ENVIRONMENTAL REVIEW TEAM REPORT

LONG HILL FARM
GUILFORD, CONNECTICUT

JANUARY 1980

ENVIRONMENTAL REVIEW TEAM REPORT
ON
LONG HILL FARM PLANNED RESIDENTIAL DEVELOPMENT
GUILFORD, CONNECTICUT

FIGURE 3. SIMPLIFIED SITE PLAN

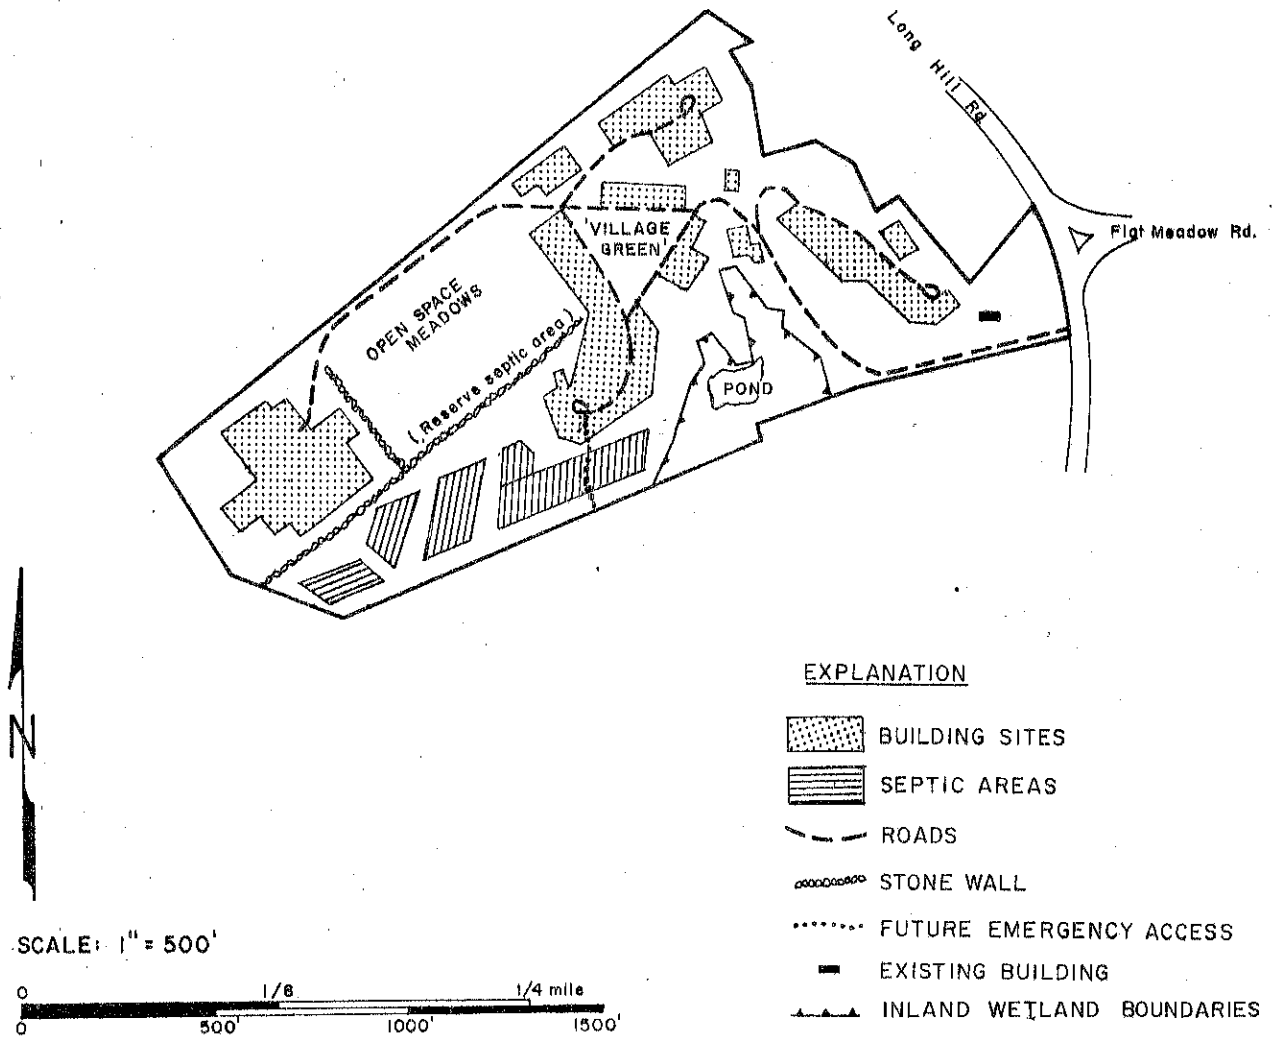
trenches well removed from the swales. The current blueprints show the easternmost part of the major septic area to be within or very close to the bottom of a swale. Some rearrangement would be preferable. In addition, septic systems should not be located in shallow-to-bedrock areas, such as the easternmost part of the property, unless very careful engineering measures are used. The major consideration in this respect is the potential for poorly renovated effluent to enter fractures in the local bedrock, contaminating a possible future water supply source either for the development itself or for nearby homes.

The road into the Planned Residential Development runs essentially parallel to the contours which means that the storm run-off flows across the road, creating the need for side road drainage and culverts. About 40 percent of the roads and parking areas are located on soils that are susceptible to frost action which means that adequate subsurface drainage is necessary. The rest of the roads and parking areas are located on shallow to bedrock soils which could mean that it will be necessary to excavate bedrock for subbase preparation. In either situation, the limitation for roads and parking is severe to moderate.

FIGURE 6.
VEGETATION TYPE MAP

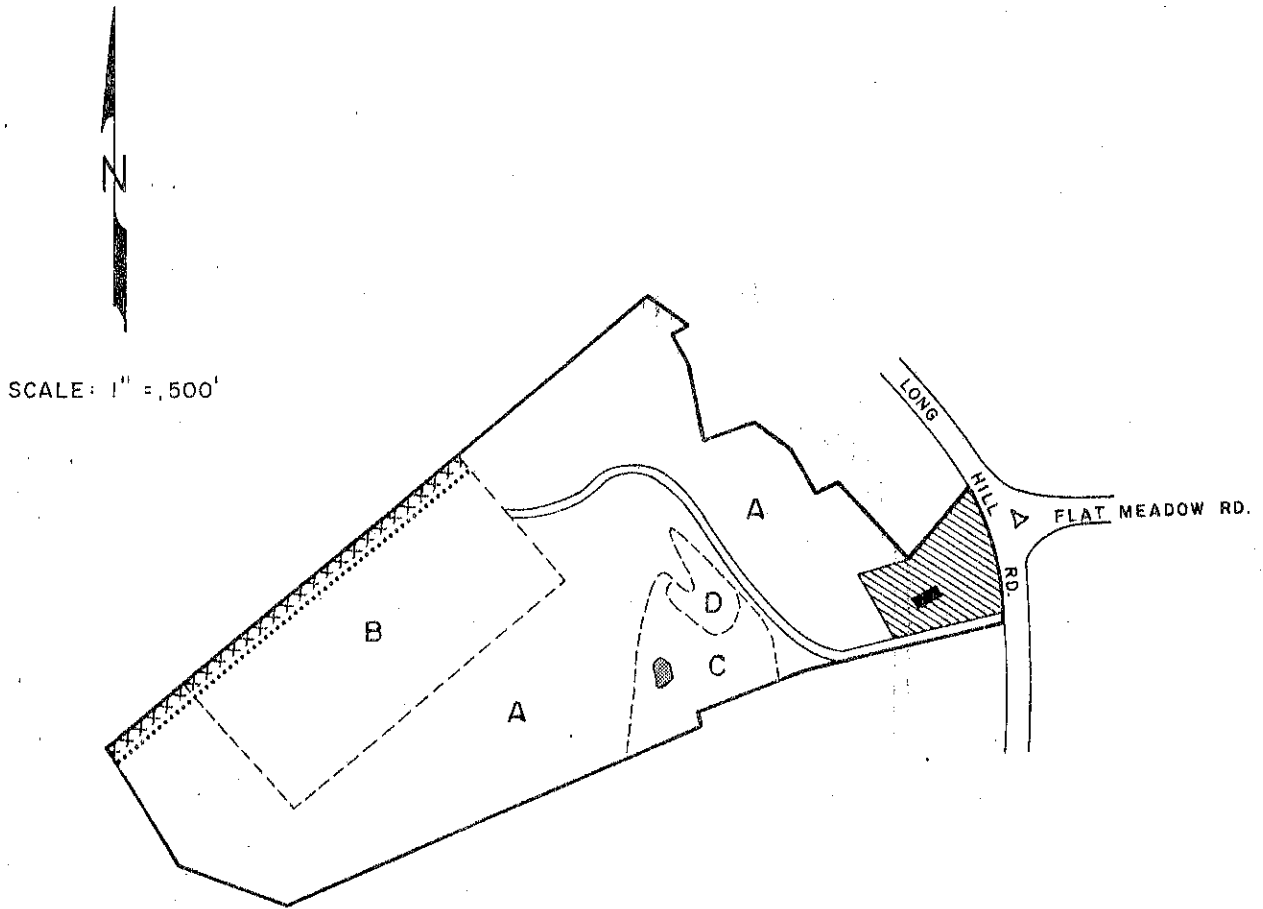
As noted in the preliminary development plans, the preservation of all of the large healthy trees which are scattered throughout the old field area (vegetation type A) would be desirable. Several flowering species present in this area should also be preserved and if need be, relocated. These species include flowering dogwood and apple trees. Ideally the flowering trees should be released from any other vegetation which reduces the amount of sunlight which reaches them. The additional sunlight available to these trees after they have been released will stimulate their flowering and increase their aesthetic value.

The high water table and accompanying poor soil aeration in the hardwood swamp (vegetation type C) and the open swamp (vegetation Type D), limits vegetation growth to species tolerant of excessive moisture. Red maple will survive under the conditions present in the hardwood swamp; however, growth rates are usually slow and tree quality is generally poor due to over-crowding. The moisture conditions are more critical in the open swamp, where no tree species can survive at present.

Windthrow is a potential hazard in the hardwood swamp. As a result of the high water table and saturated soils, the trees present are shallow rooted and unable to become securely anchored. The crowded condition of the trees in this stand increases the potential for windthrow if disturbances occur. At present these trees rely on each other for stability. Any openings which would allow wind to pass through rather than over this stand will increase the windthrow hazard and should be avoided if possible.

The planting of a buffer strip of several staggered rows of a mixture of white pine and hemlock planted approximately eight feet apart on the northern boundary of this property will eventually produce a vision and sound barrier between Guilford High School and the proposed complex. Fruiting and flowering shrubs such as crab apple, silky dogwood and autumn olive could also be planted in this buffer strip preferably to the south of the conifer planting. The entire buffer zone need not take up any more than a 40 to 50 foot strip.
